Access Compliance Report

Public Rights-of-Way

(Curb Ramps)

Intersection ID: 24298	Main Street: MIROW_PL	Cross Street: WISMAR_CT	Location: S
ADA ID: 8A99977808BD	Ramp Type: PerpDiag	Initial Pass/Fail: Fail	Overall Compliance: No
		Severity Score: 22.5

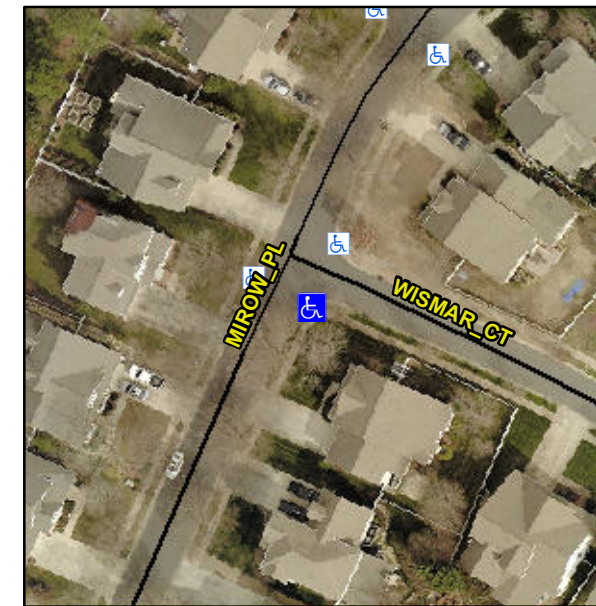
Not Found, R304.5.1, R304.2.2, R304.5.3

Compliance	Description	Data	Compliance	Description	Data
N/A	Ramp Length (in)	47.0	No	Ramp Slope (%)	9.3
No	Ramp Width (in)	47.0	No	Ramp XSlope (%)	3.8
N/A	Flare Type LT	N/A	N/A	Flare Type RT	N/A
N/A	Flare Slope LT (%)	N/A	N/A	Flare Slope RT (%)	N/A
N/A	Flare Traversable LT?	N/A	N/A	Flare Traversable RT?	N/A
N/A	Landing Length (in)	N/A	N/A	DWS Provided?	N/A
N/A	Landing Width (in)	N/A	N/A	DWS Contrast?	N/A
N/A	Landing Slope (%)	N/A	N/A	DWS Length (in)	N/A
N/A	Landing X Slope (%)	N/A	N/A	DWS Full Width?	N/A
N/A	Landing Curb? (Y/N)	N/A	N/A	DWS Offset (in)	N/A
N/A	Shared Landing?	N/A			
N/A	Gutter Ponding?	N/A	N/A	Gutter Slope (%)	N/A
N/A	Gutter Lip Ht (in)	N/A	N/A	Gutter X Slope (%)	N/A
N/A	Painted X Walk1?	No	N/A	Painted X Walk2?	No
	X Walk 1 Direction	To NE		X Walk 2 Direction	To NW
N/A	X Walk 1 Width (in)	N/A	N/A	X Walk 2 Width (in)	N/A
	X Walk 1 Slope (%)	3.6		X Walk 2 Slope (%)	0.7
	X Walk 1 X Slope (%)	2.3		X Walk 2 X Slope (%)	1.6

Remove & Replace Curb Ramp With Two New Directional Ramps or Equivalent.
